## Landscape Further Information Response

In relation to the commercial Development at;  
Fonhill Road, Liffey Valley, Clondalkin, Dublin 22

*Planning Ref:*  
SD22A/0363

**RE: Response to further information request**

Figure 4.3: Key Elements of South Dublin County Council’s GI Network

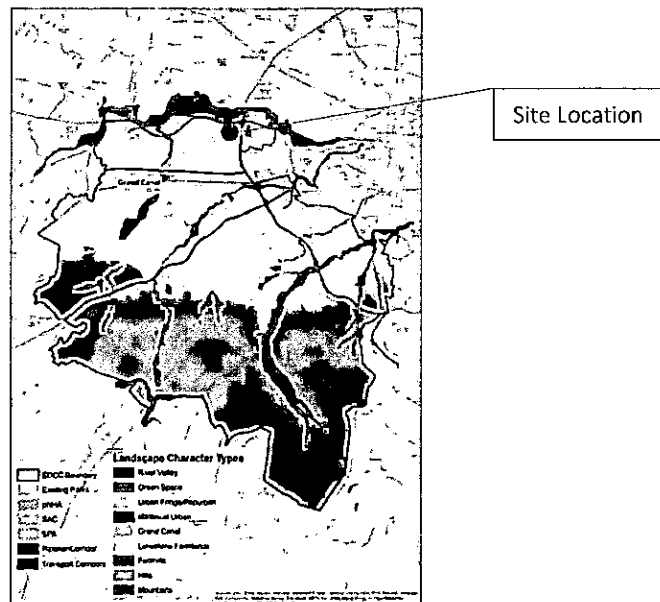
Site location plan in context to wider GI of the county

The subject land characteristic is classified as urban fringe, located on the M50 Primary GI corridor within the major retail zone of Liffey Valley. This brownfield site has become overgrown with herb layer of vegetation, and larger scrub material beginning to emerge along the wayleave corridor that runs along the eastern boundary. The M50 Primary GI corridor sits outside the site eastern boundary, with evidence of the canopy overhang emerging onto the site.

Site approximate location in Figure 4.3 Key elements of South Dublin’s County Council’s GI Network

Existing Site Survey

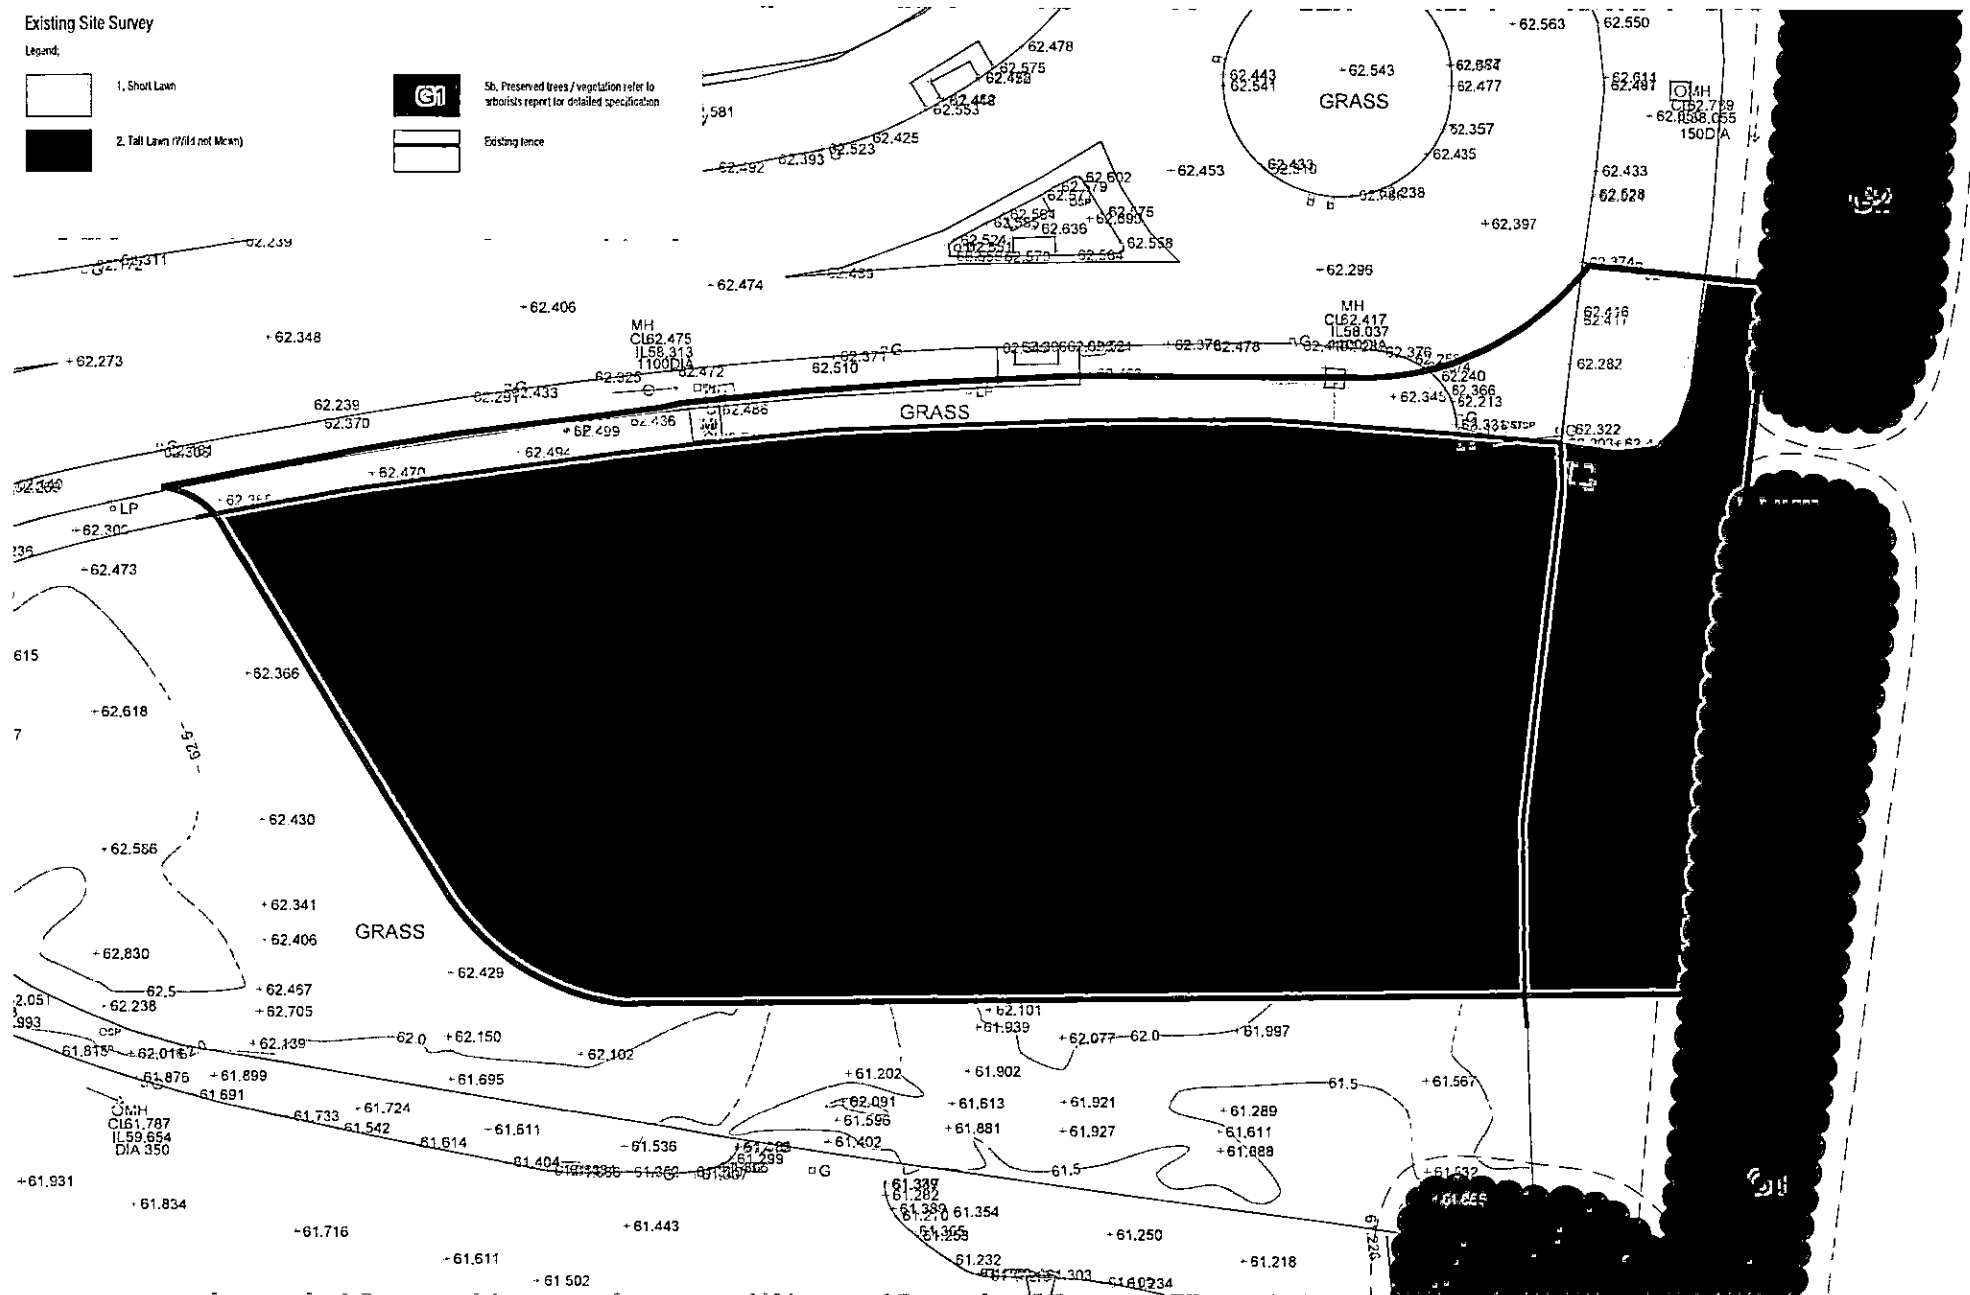
- iv. *Development should seek to enhance or restore features that act as ecological corridors, particularly water features, hedgerows, tree lines, areas of un-cultivated land. These, or some element of them, should be incorporated into the proposed development to create pathways for wildlife and / or increase amenity value.*

Refer to Arborist tree survey and protection plan 221123-P-11, and PP397-01-01 Existing site survey. This is a brownfield site in an industrial retail park adjacent to a roundabout. The woodland group of trees that run along the eastern boundary (outside the property boundary) shall be protected during construction. The Wayleave strip running between the group of trees and the proposed site shall be managed as tall grass, providing linkage to the M50 Primary GI corridor.

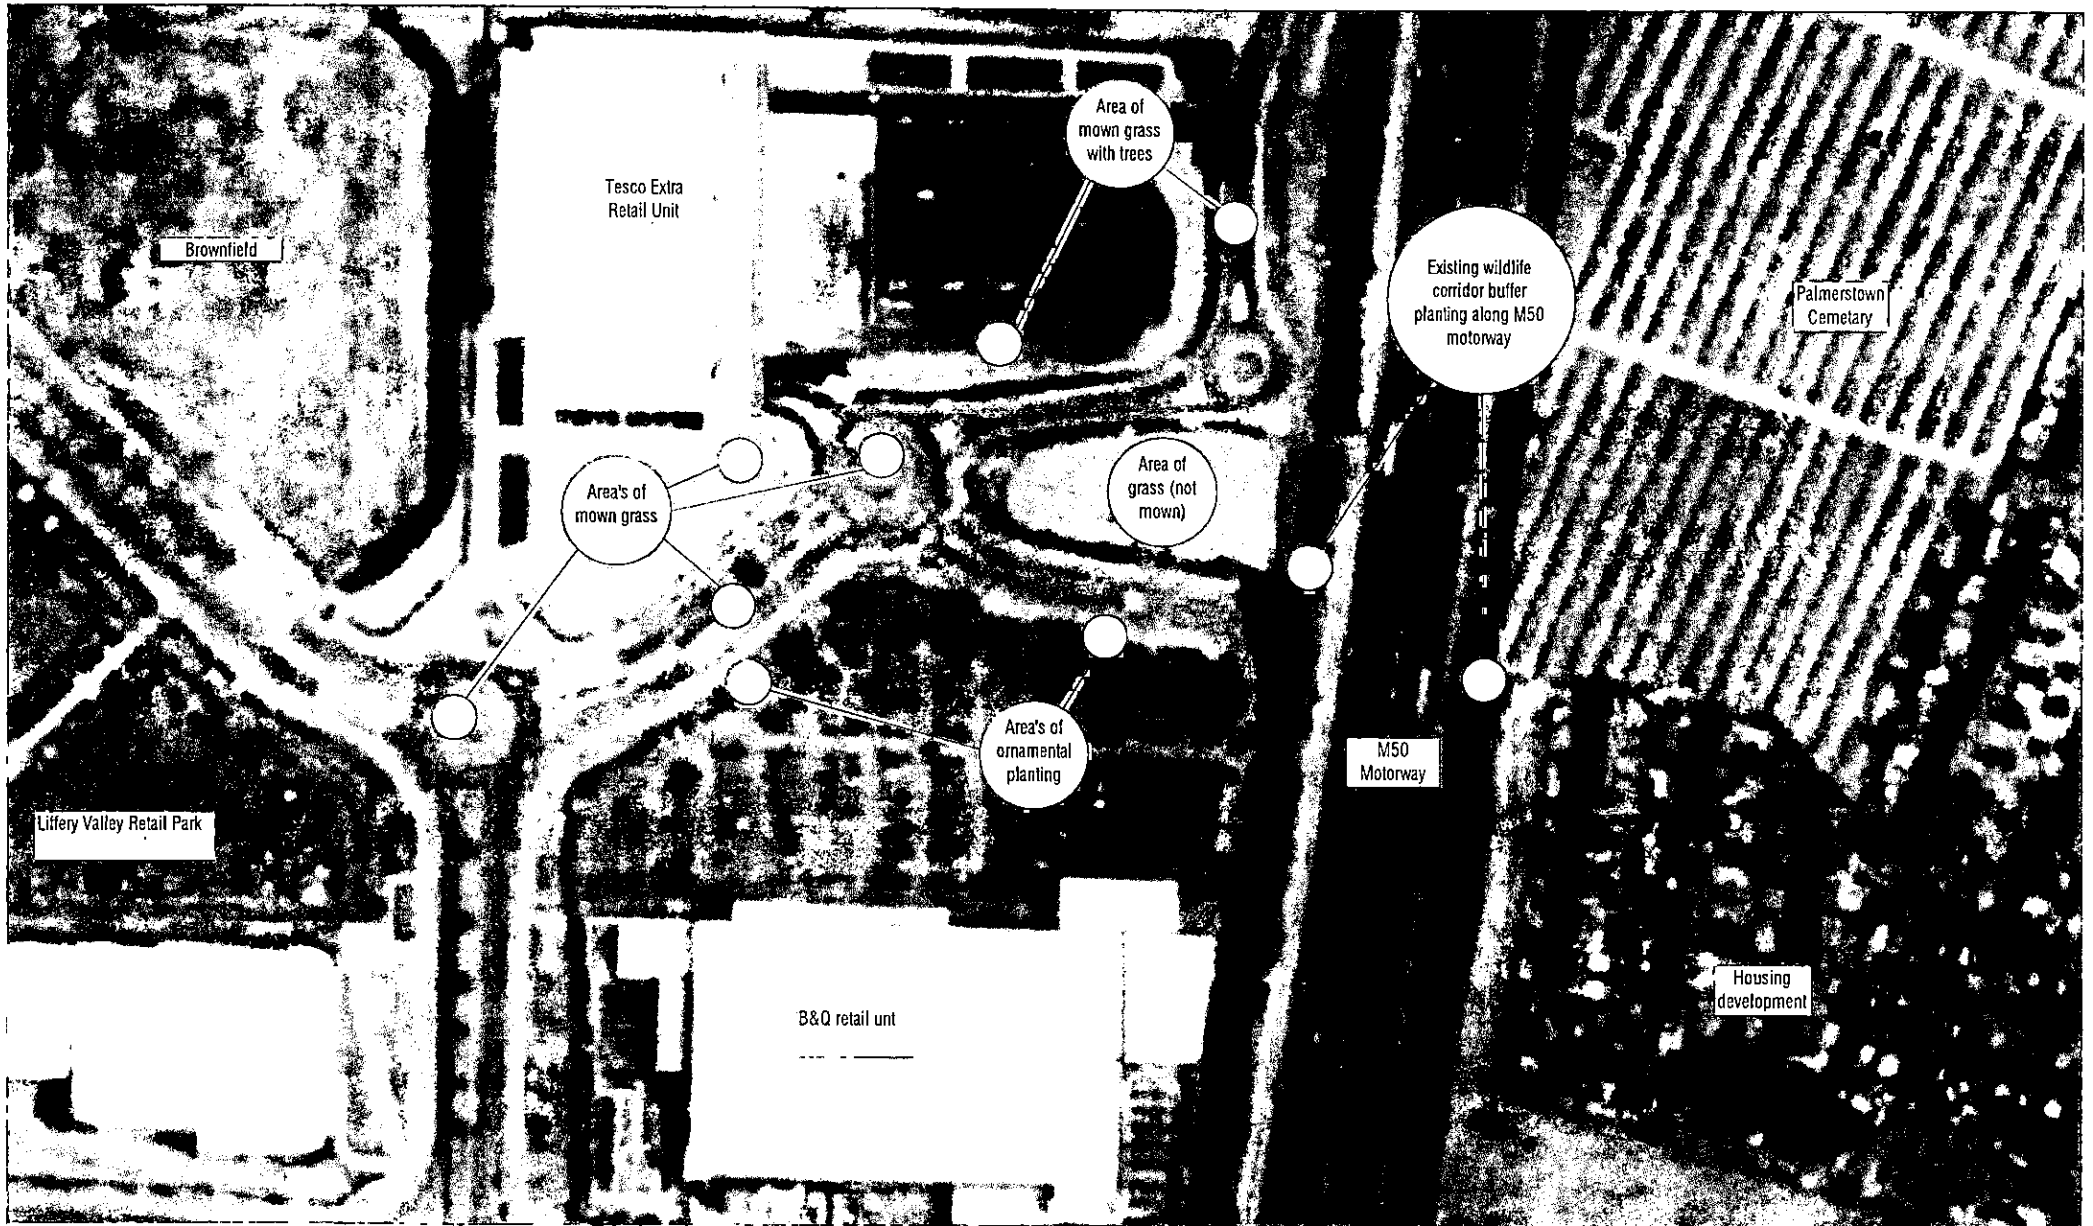
- v. *v) Development sites which are not located proximate to designated GI Cores or Corridors should identify the nearest designated GI Core, Corridor or Steppingstone and make provision for GI interventions on the site which could eventually provide a link to local Stepping Stones, Cores or Corridors;*

Refer to PP397-01-02 Existing site green factor analysis.

Project	Landscape Green Factor objectives	Drawn	PP397-02-02
Scale	1:500 1 <sup>st</sup> A3	Date	JAN 2023
Client	Certas Energy Ireland Limited	Checked	JMC
Location	Fonthill Road, Liffey Valley	Author	JMC

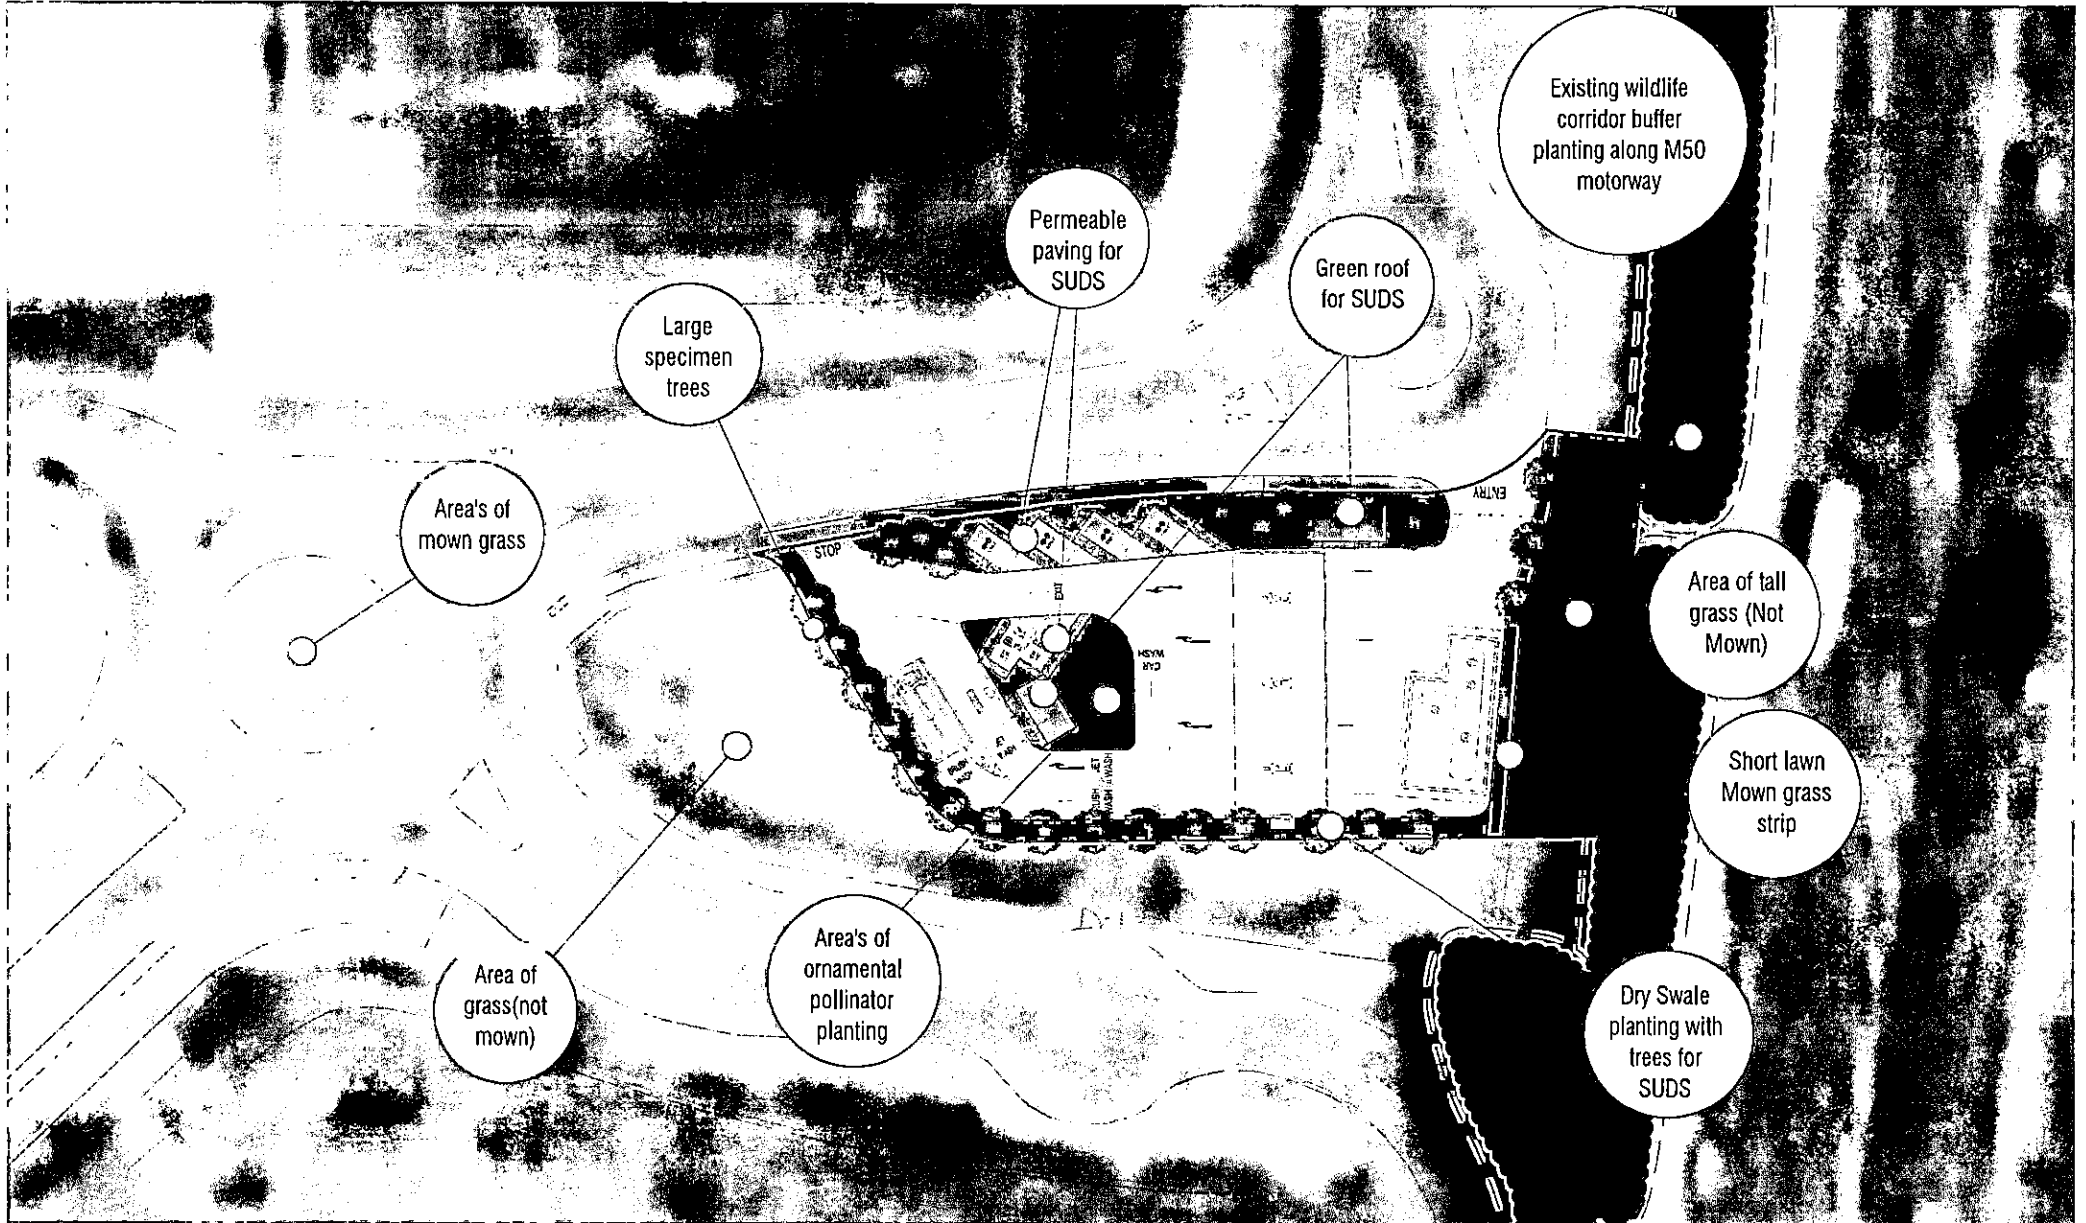
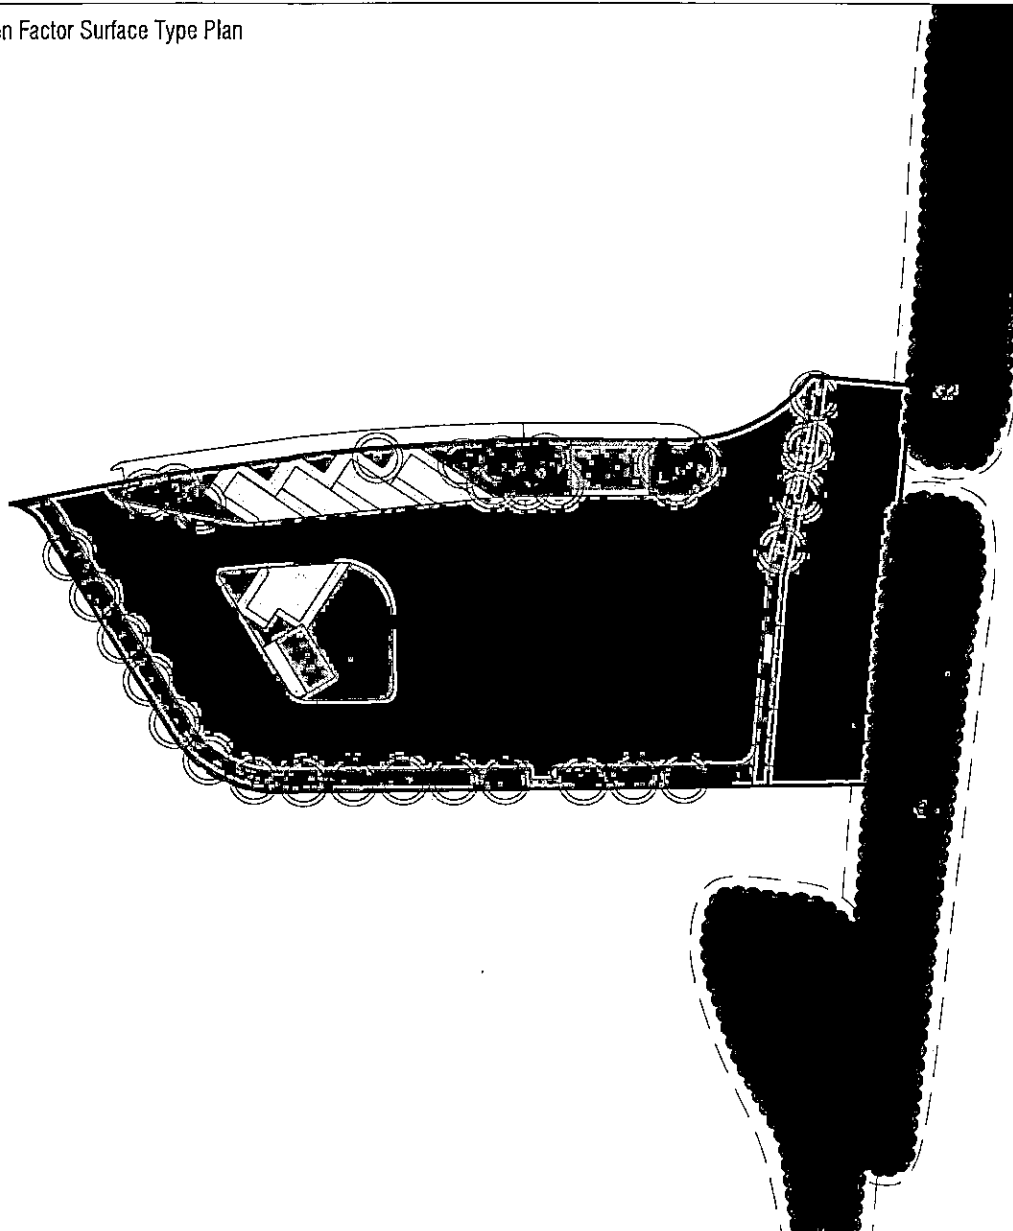
- vii. *The Green Infrastructure Plans shall include:*
- a. *Site location plan showing the development site in the context of the wider GI as shown on the Council's GI Plan for the County.*
  - b. *Site survey and analysis, identifying existing GI Infrastructure and key assets within the site.*
  - c. *Indicate how the development proposals link to and enhance the wider GI Network of the County.*
  - d. *Proposed GI protection, enhancement, and restoration proposals as part of the landscape plan, where appropriate, for the site."*

Refer to PP397-01-01 Existing site survey, PP397-01-02 Existing site green factor analysis, PP397-02-01 Proposed landscape masterplan, and PP397-02-02 Proposed green factor objectives and PP397-02-03 Green Factor surface type.

Project	Landscape specifications	Project No.	PP397-04-01
Client	Certas Energy Ireland Limited	Scale	A3
Date	JAN 2023	Author	SH
Project Location	Fonthill Road, Liffey Valley	Checker	JMC

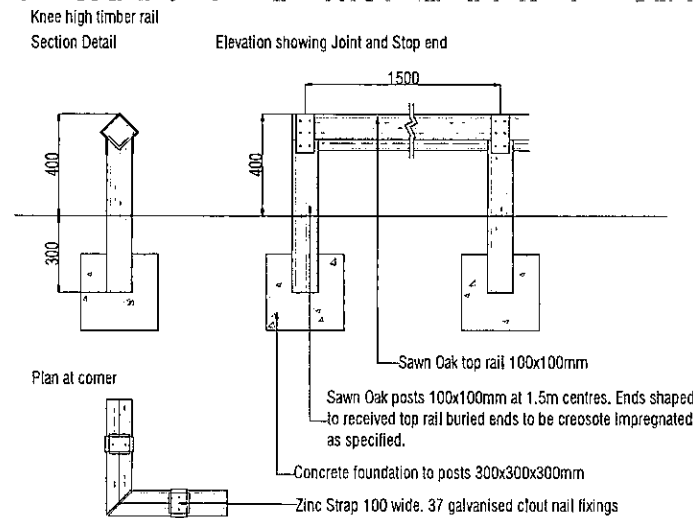
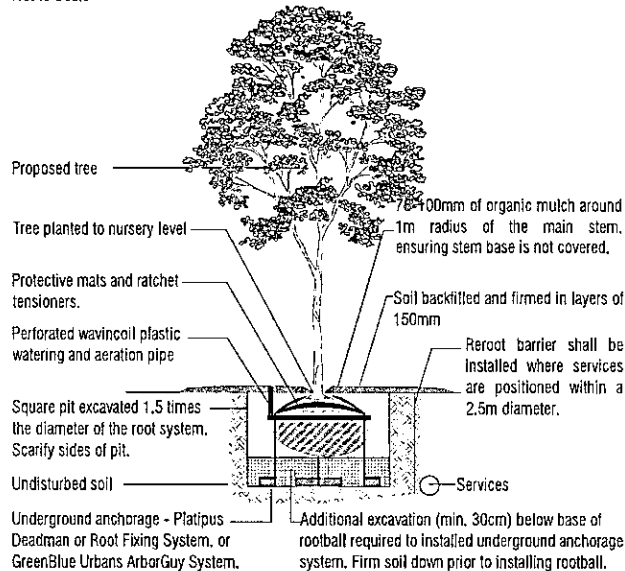
*b) Planting material where possible should be Irish Grown Nursey Stock and the importation of foreign planting material should be avoided within the proposed planting scheme."*

Refer to PP348 -04-01 Landscape specifications.

All plant material where possible should be Irish grown Nursery Stock and the importation of foreign planting material should be avoided within the proposed planting scheme
